2025 Prox Brackets

- Due to vendor supply issues, flush box proximity sensor 77998 is no longer available.
- Prox sensor 77998-1 replaces it, but new brackets are needed. Use the following slides to determine which parts are needed.

BW10383-KIT FOR A40HP & M30

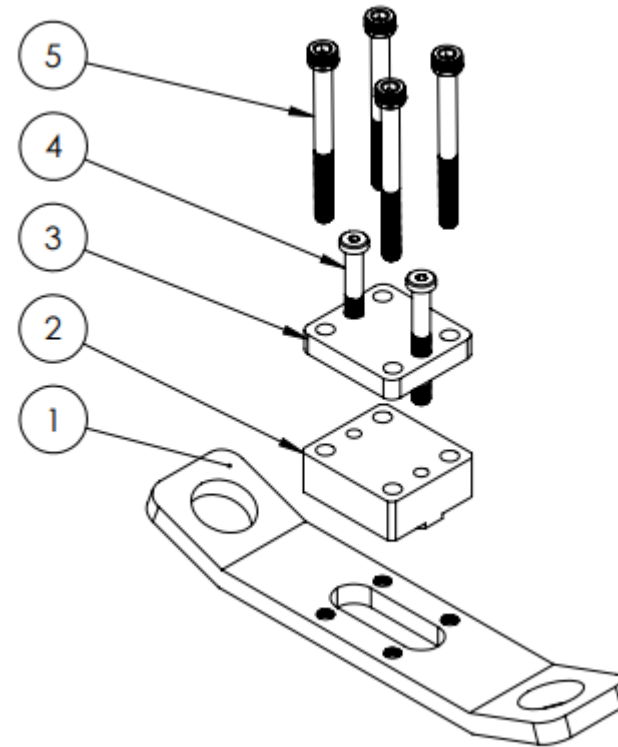
- Starting in early 2024 bracket design incorporated a new position locking mechanism. For 2024+ A40HP & M30 pumps, only BW10383-1 and screws are needed. For earlier pumps use BW10383-KIT.
- Use gap distance of 1/8"
